BRIEF DESCRIPTION OF REQUEST
REQUEST DRB APPROVAL OF THE EPC APPROVED SITE DEVELOPMENT PLAN FOR BUILDING PERMIT AND SUBDIVISION 18EPC-40008 AND 18EPC-40009

Project# 1011553
18EPC-40008 Site Development Plan for Subdivision
18EPC-40009 Site Development Plan for Building Permit

**EPC APPROVED SITE DEVELOPMENT PLAN FOR BUILDING PERMIT & SUBDIVISION FOR SU-1 /C-1 USES
– 3500 COORS BLVD. NW, ALBUQUERQUE, NM. 87120 (1.9 ACRES)**

SITE PLAN FOR BUILDING PERMIT

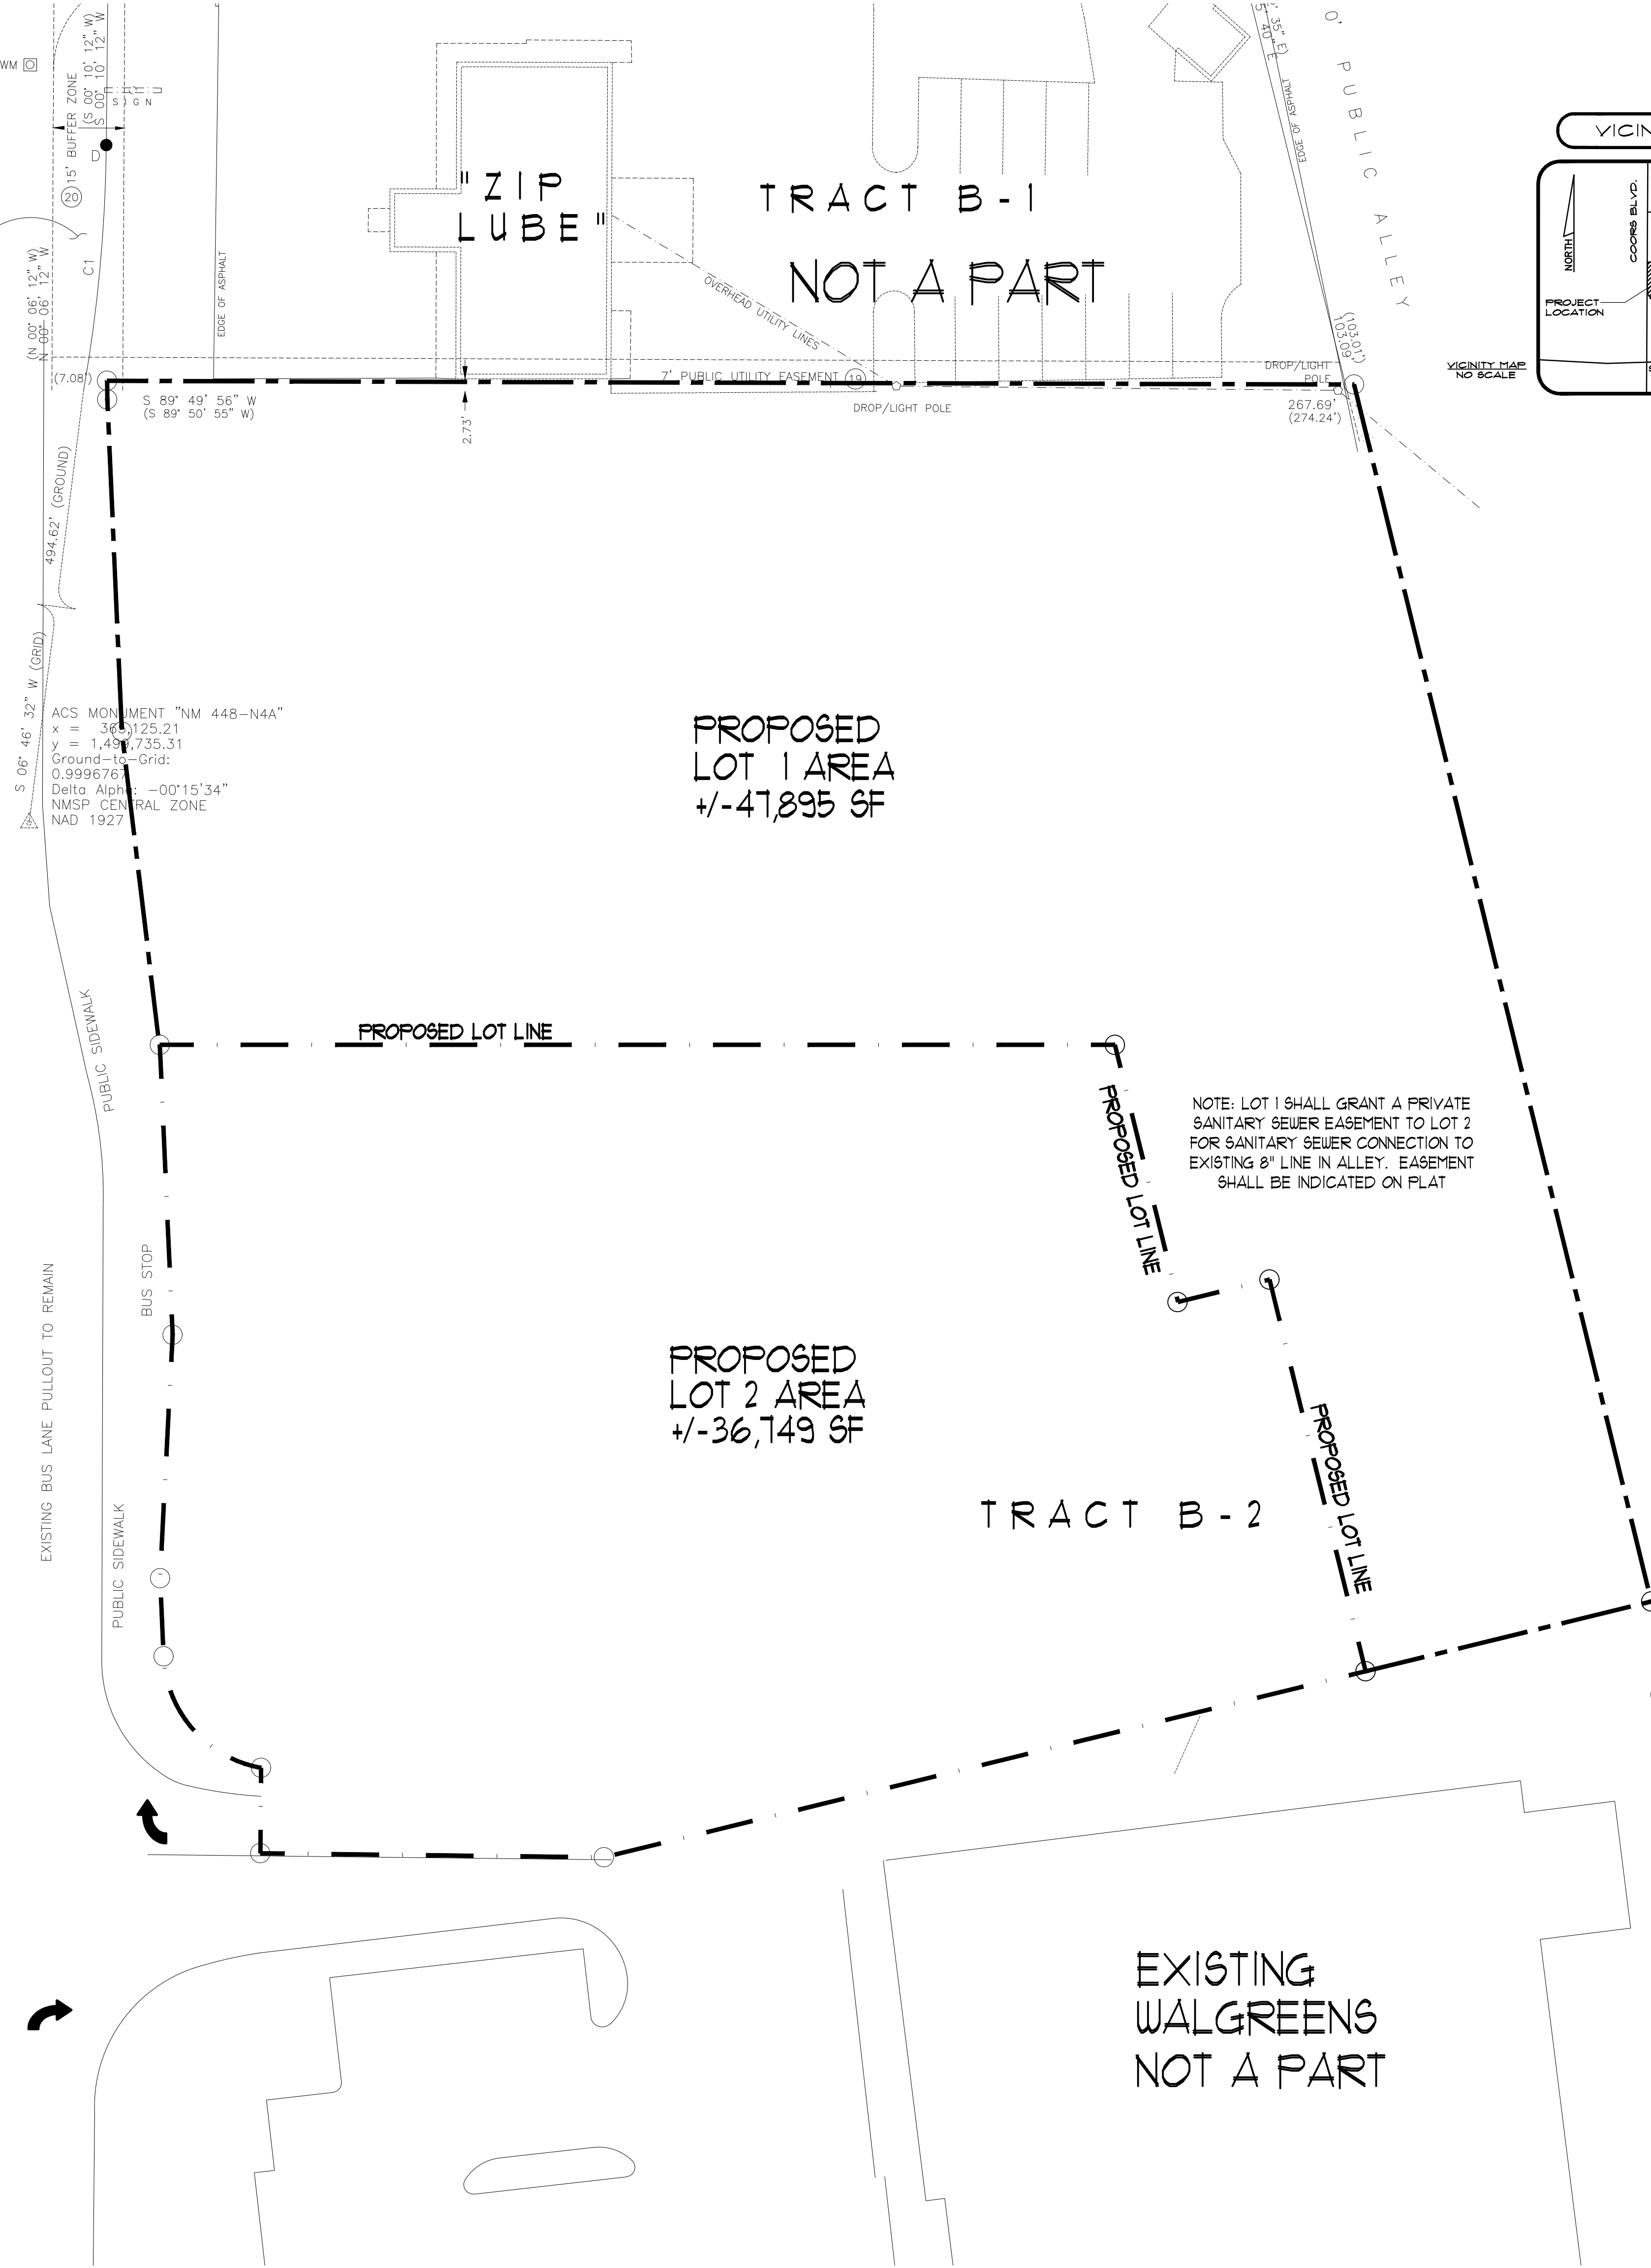
- #1011553 (#23) bollards noted on Pg. BP1 (site plan), must not hinder ability to completely open enclosure gates for safe refuse truck access. All new/proposed refuse enclosures built to COA minimum requirements must include ½" expansion joint between slab/apron, 4" sanitary drain for any food/kitchen services, etc.

- # 10 11553 (#23) bollards noted on Pg. BP I (site plan), must not hinder ability to completely open enclosure gates for safe refuse truck access. All new /proposed refuse enclosures built to COA minimum requirements must include ½" expansion joint between slab /apron, 4" sanitary drain for any food/kitchen services, etc.

A note was added that the bollards on BP1 must not hinder the

DATE 3/27/2018	SHEET C2.1
SCALE AS NOTED	of 1

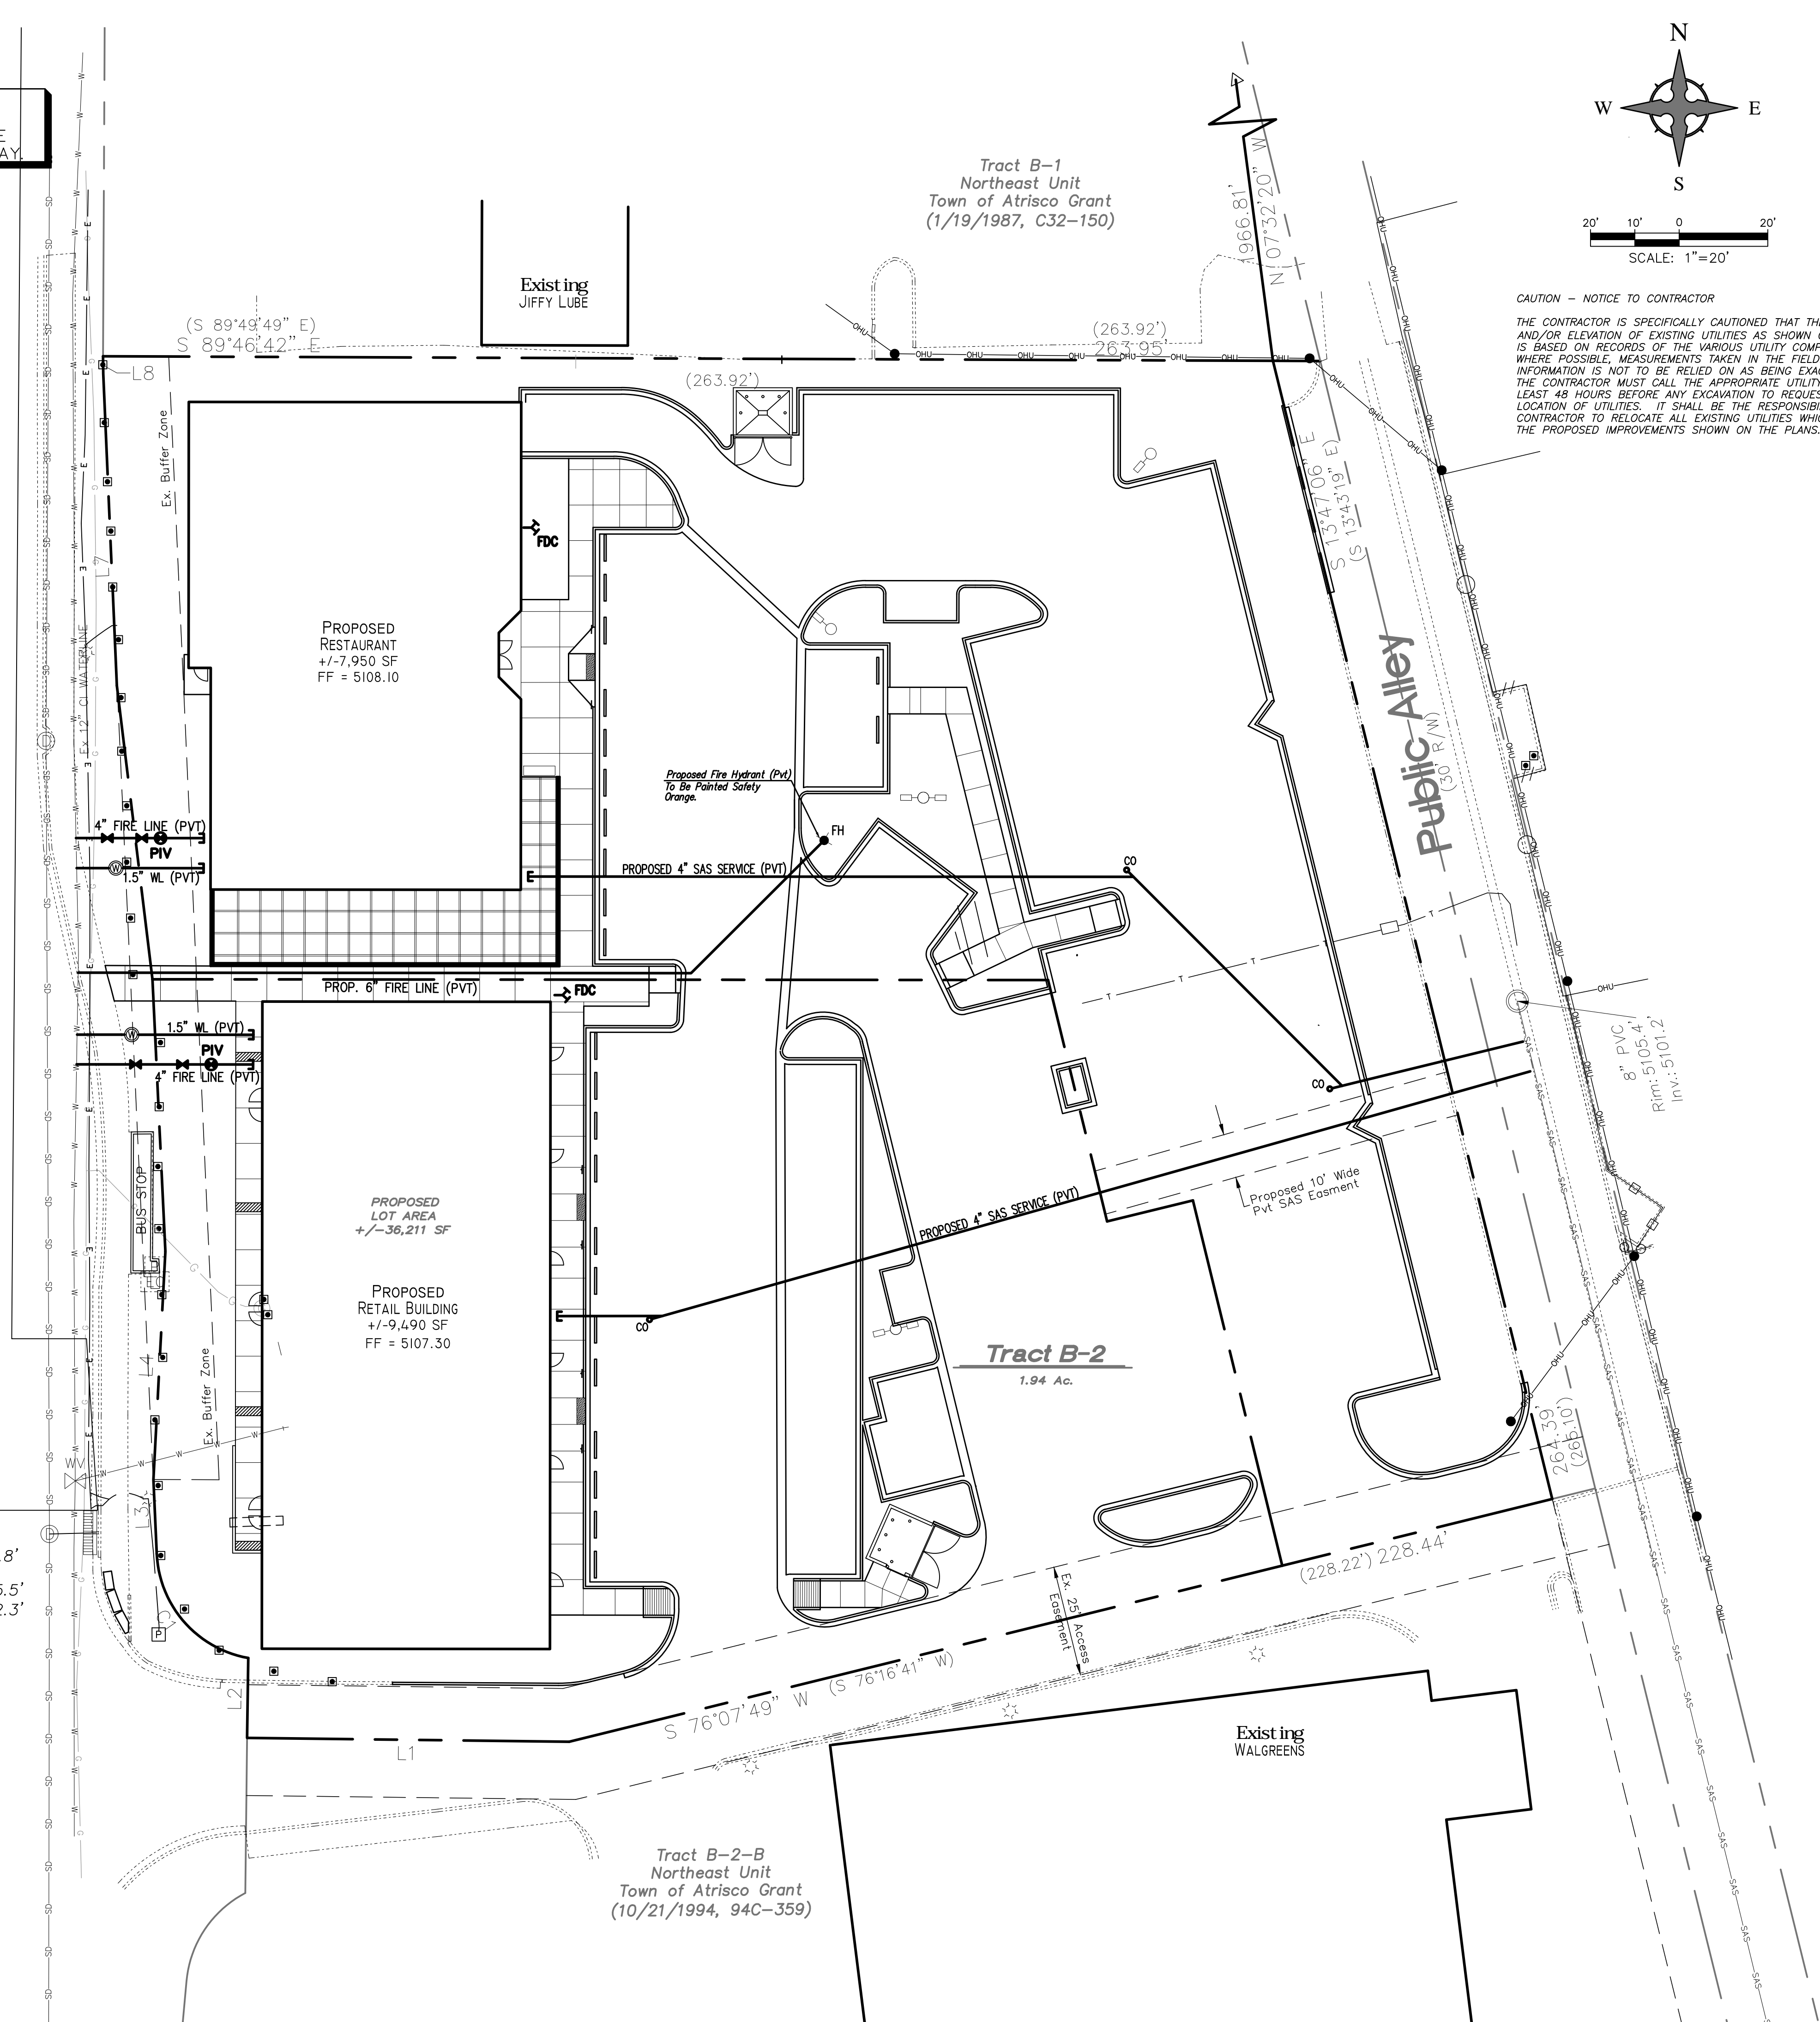
- The proposed utility plan shows meters within the property line. Please note that all meter services up to and including the meter box shall be located within the public right-of-way.

- The proposed utility plan shows meters within the property line. Please note that all meter services up to and including the meter box shall be located within the public right-of-way.

A note has been added on the Civil Utility Plan that states, "there shall be no bends from the distribution main in the right-of-way to the meter located at the property line.

A note has been added stating the fire lines for both proposed lots will require both public and private valves.
